PLANNING CLEARANCE
(Single Family Residential and Accessory Structures)
Grand Junction Department of Community Development

BLDG ADDRESS 2393 W. PLATEAU CT.

APPROVAL FOR BUILDING PERMIT
Ridges Architectural Control Committee (ACCO)

2393 W. Plateau Ct

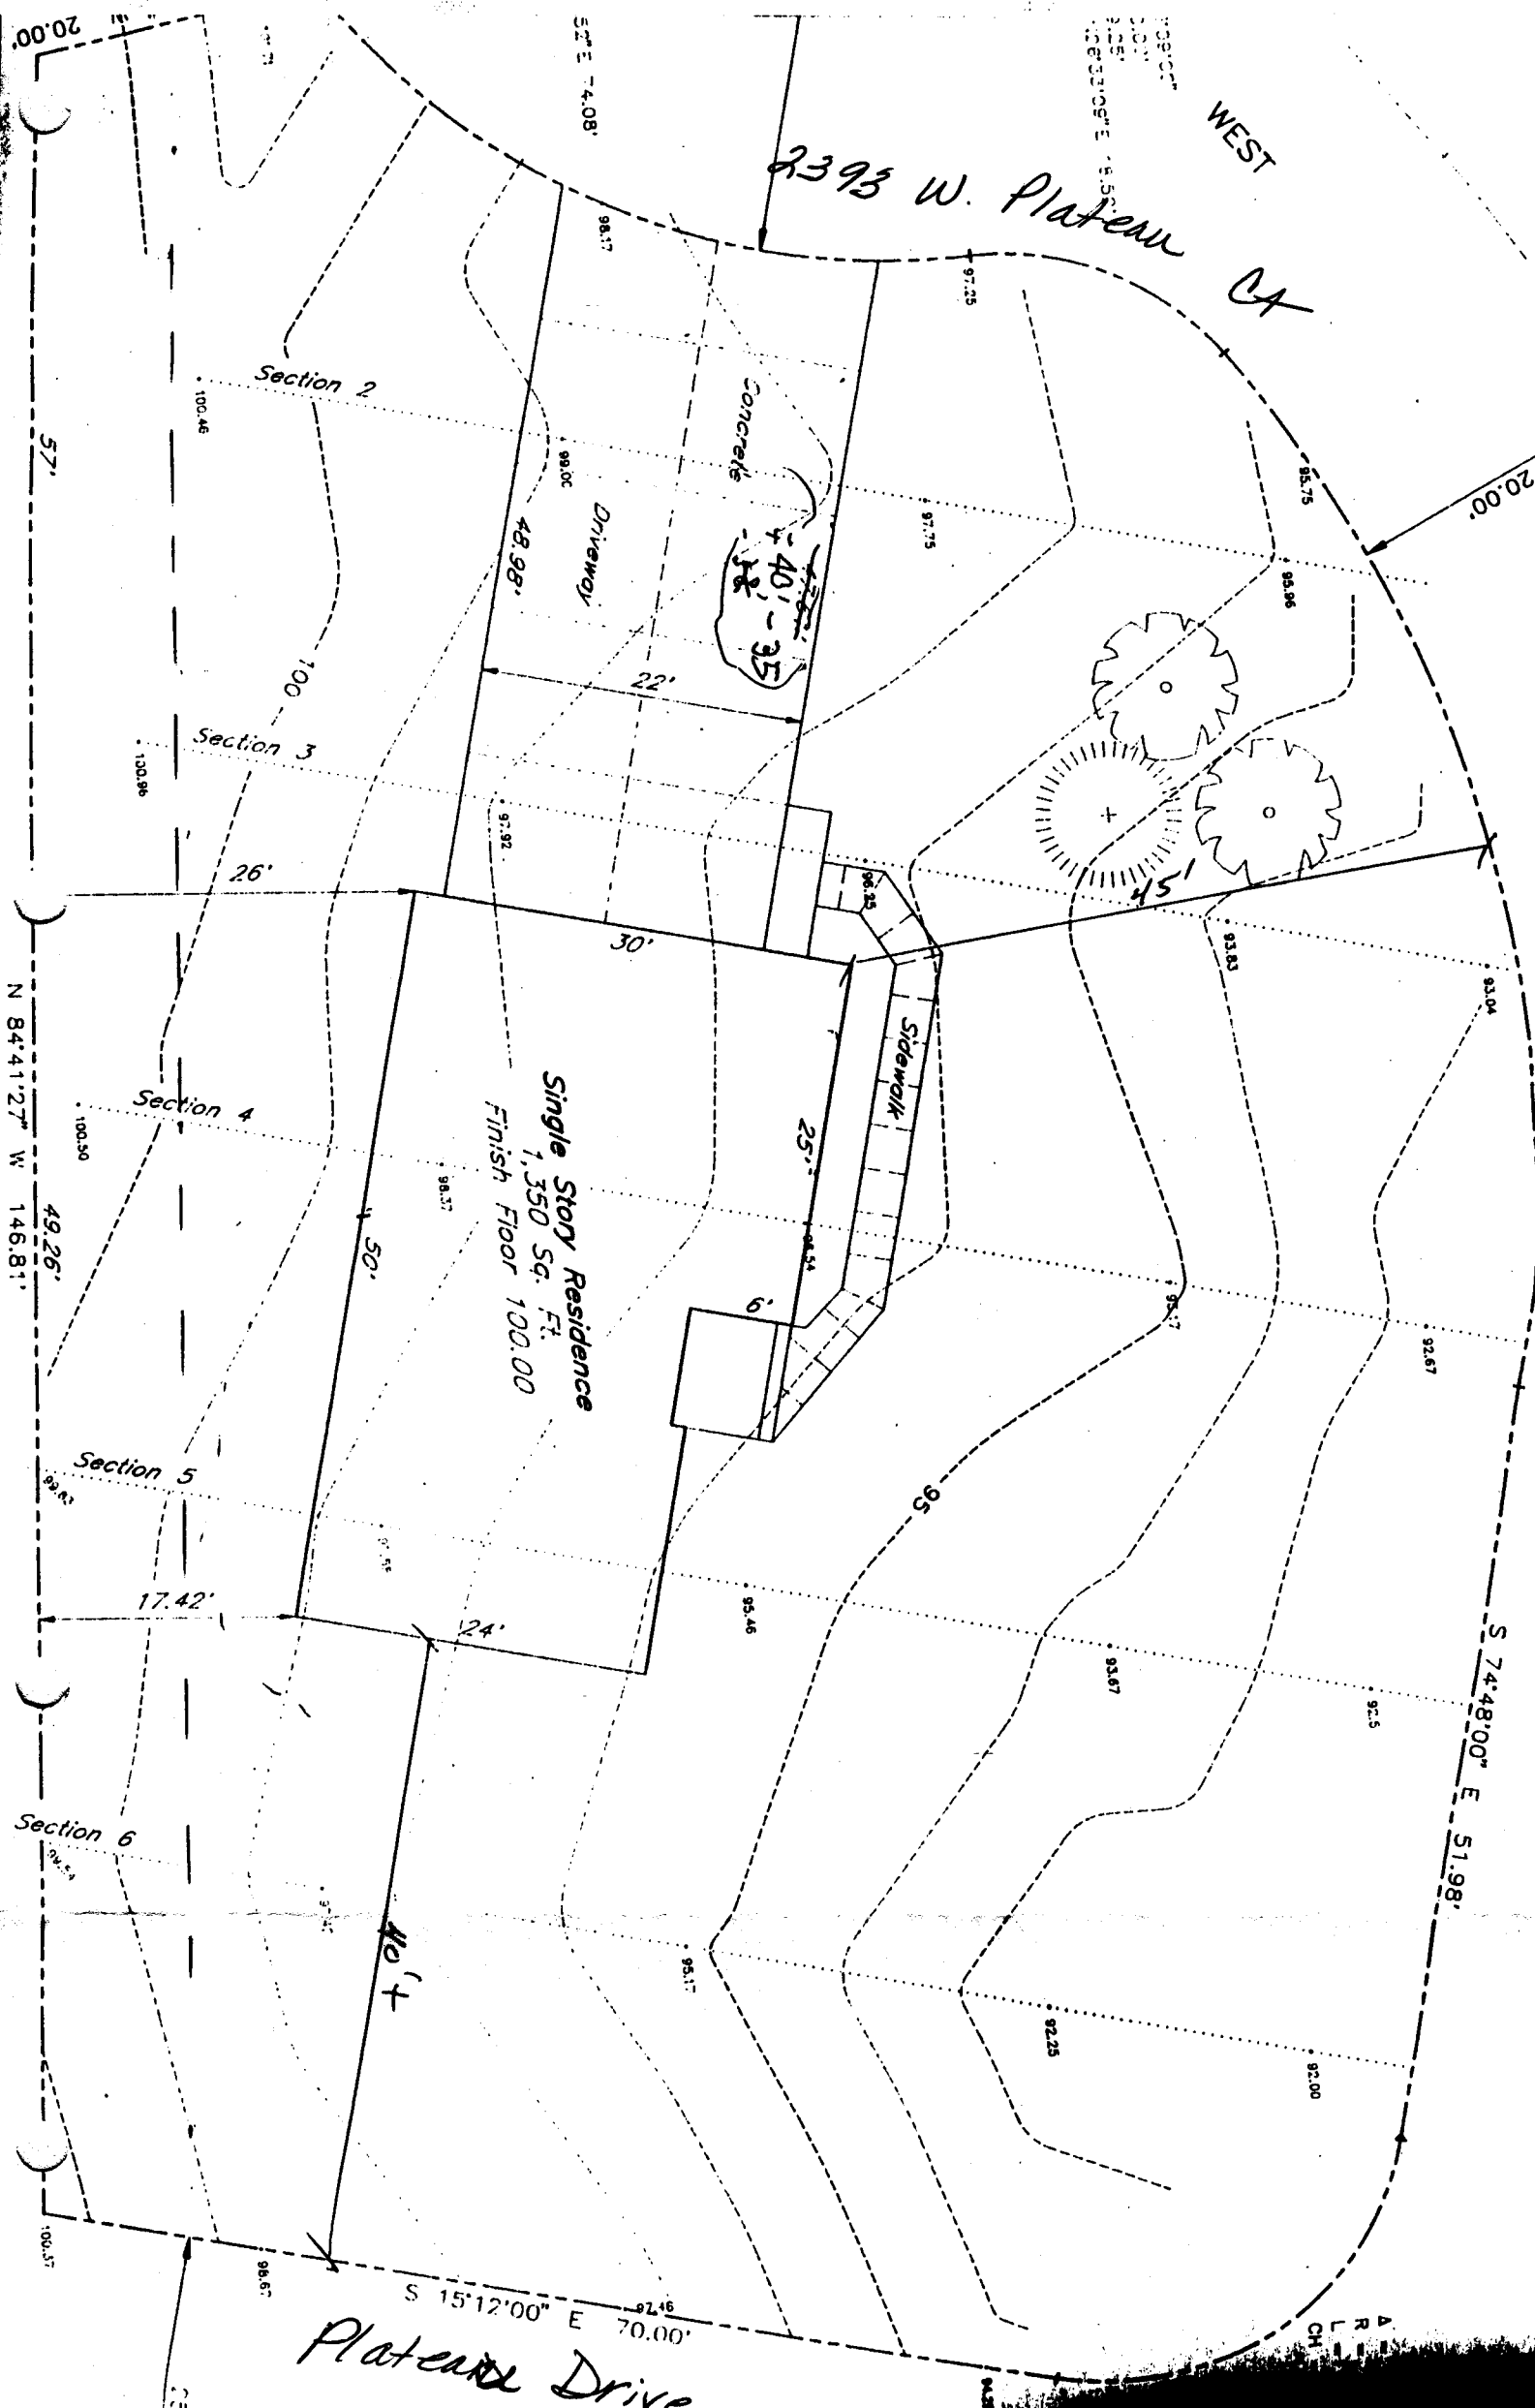
ACCO accepts fact that 1st floor does not meet ^{COVENANTS} side but
the overall design meets standards.
